PLANNING COMMISSION AGENDA REPORT

Subject: Proposed Four-Story Multiple-Family Residential at 444-450 First Street

RE: 450 FIRST STREET

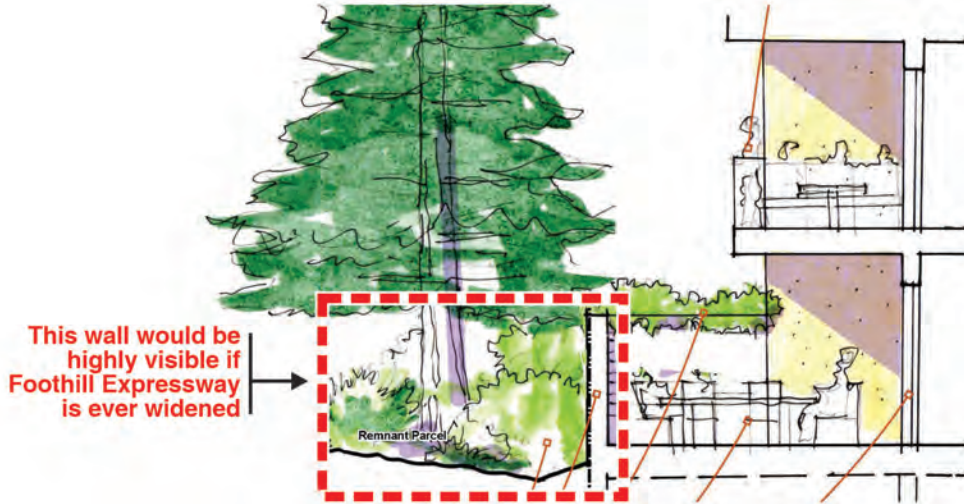
2. The Planning commission recommended against glass balcony railings on the Foothill Expressway facade. There are, however, two frosted glass railings shown on the upper floor. And, there are two railings noted as "Dark Bronze metal finish", but I am unclear as to the material proposed.

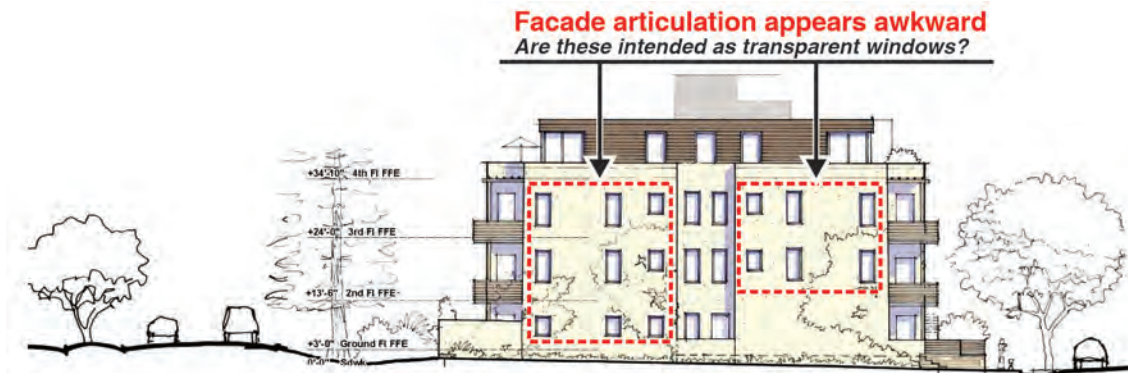
- The patio walls along the Foothill Expressway frontage would become strong visual elements on the roadway if the expressway were ever widened, and much of the mature landscaping were removed.

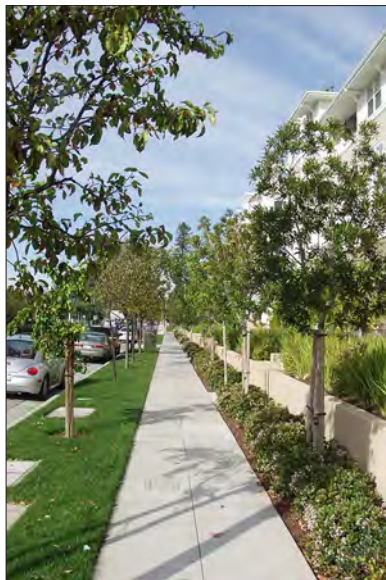
- The tall wall on the south facade facing the parking lot may be exposed to view for some time until new development occurs on the parking lot site. Currently, windows are shown on that facade, but it is unclear whether they are transparent to be closed off in the future or faux windows.

- There are several bedrooms which may only open to small light wells when adjacent development is constructed on the adjacent parcels.

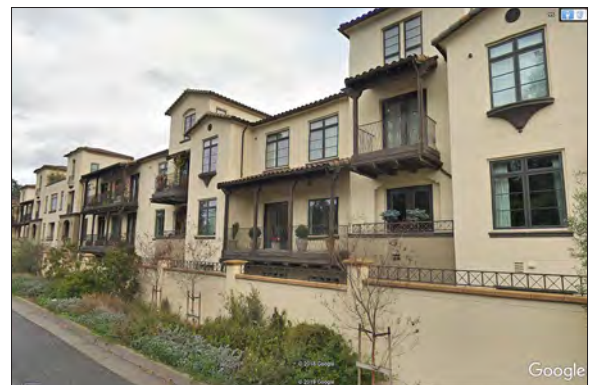
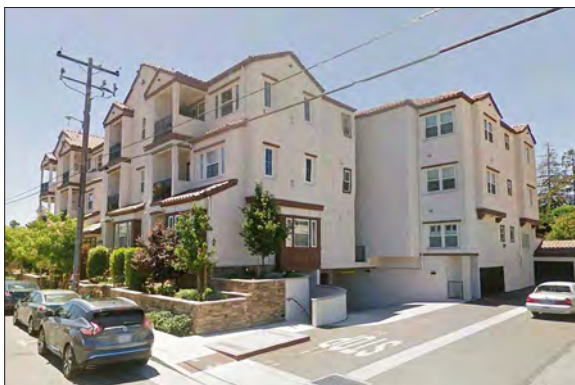
Another approach is to add trompe l'oeil painted murals to visually simulate windows and details - see example below.

Proposed East Elevation

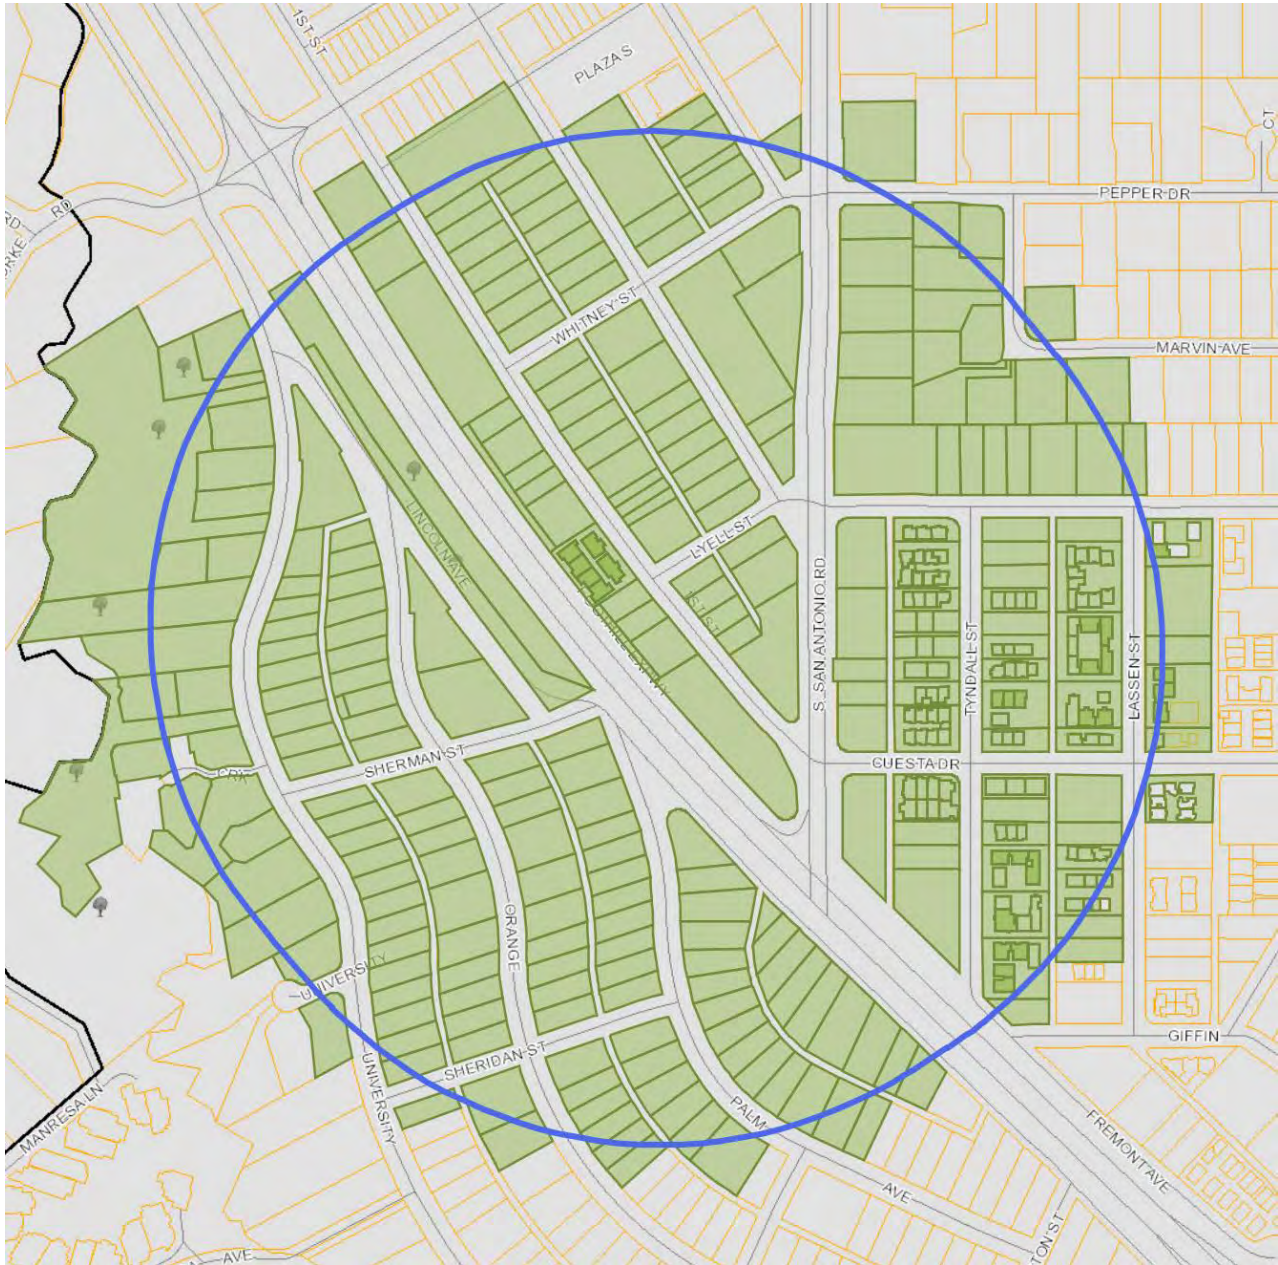
The two First Street facades differ both in terms of the amount of human scale detail - an element which was recommended in the Downtown Design Guidelines. Consideration could be given to adding projecting sun shades to the facades to increase the visual interest.
